Dr. Grayson Badgley  
Black Rock Forest  
65 Reservoir Road  
Cornwall, NY 12518

August 25, 2020

Mr. Sami Osman  
Climate Action Reserve  
818 W. 7<sup>th</sup> Street, Suite 710  
Los Angeles, CA 90017

Grayson Badgley  
SEP Working Group Member

**Figure 1:** The percent change of SOC with depth, when comparing no-till (NT) to full-inversion till (FIT). Clipped from Angers and Eriksen-Hamel (2008).

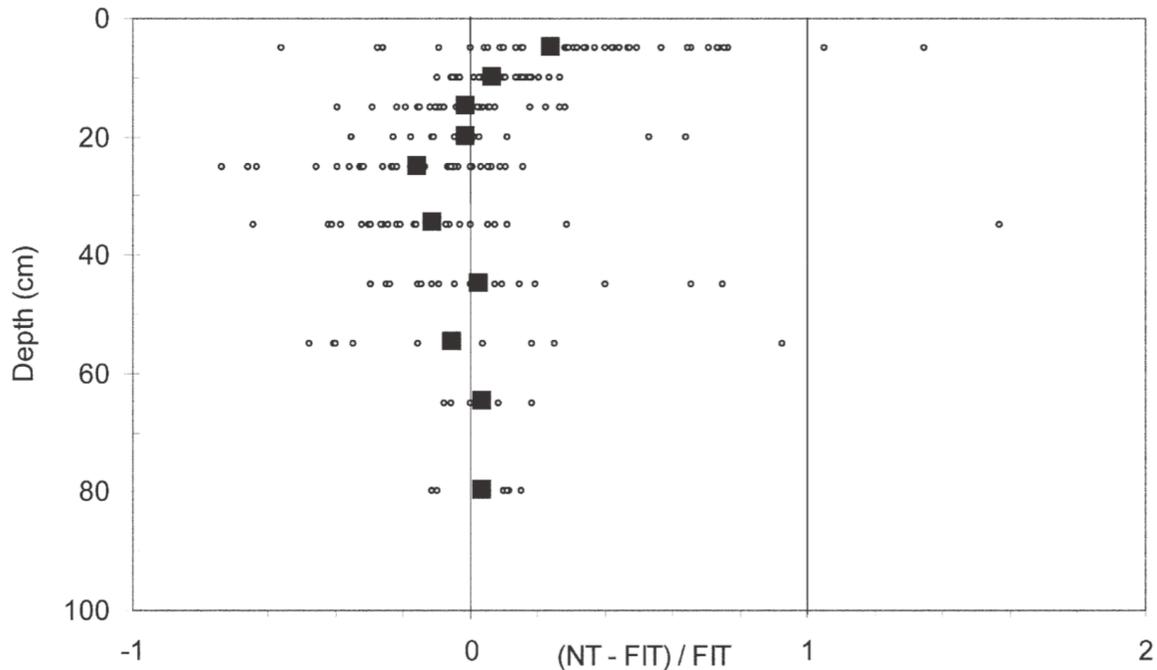
As written, the protocol requires a fixed sampling depth of 30 centimeters for evaluating SOC (Section 6.4.1, Table 6.1). However, there is substantial evidence that change of tillage, such as reduced- or no-till, commonly change the vertical distribution of SOC. This manifests in a commonly documented pattern of SOC loss just below the previous plow depth, offset by SOC accumulation above the previous plow depth (Figure 1).

Failure to account for this pattern would result in over-crediting. The SEP should adopt one of two options:

- Maintain a fixed sampling depth, but change that depth to something like 1 meter.
- Require sampling depth extend a fixed depth below historical plow depth. Eyeballing Figure 1, something like 30 cm below plow depth might be sufficient for distinguishing redistribution of SOC from the true accumulation of SOC.
